SB-10056240-1714

PI0845, Vehicle Electronic Control Unit (VECU), Reprogramming

(July 2014)

W8034103

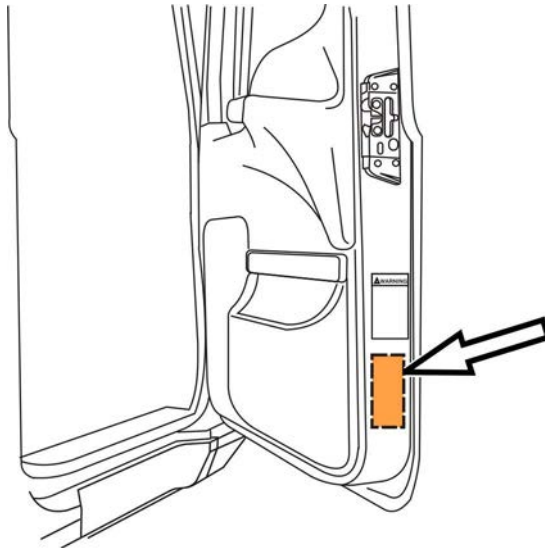
Note: To signify that the campaign has been completed, using a permanent-type marker (such as a Sharpie®) write the campaign number (PI0845) and completion date in the spaces provided on the Campaign Completion label located inside the cab as shown in the illustration below. If a label is not already affixed inside the cab, apply a label (part No. TS897) and supply the information as required. Campaign Completion labels are available in packs of 50 and can be ordered by faxing a completed BR313 to Pacesetters Business Services at 610-264-9465.
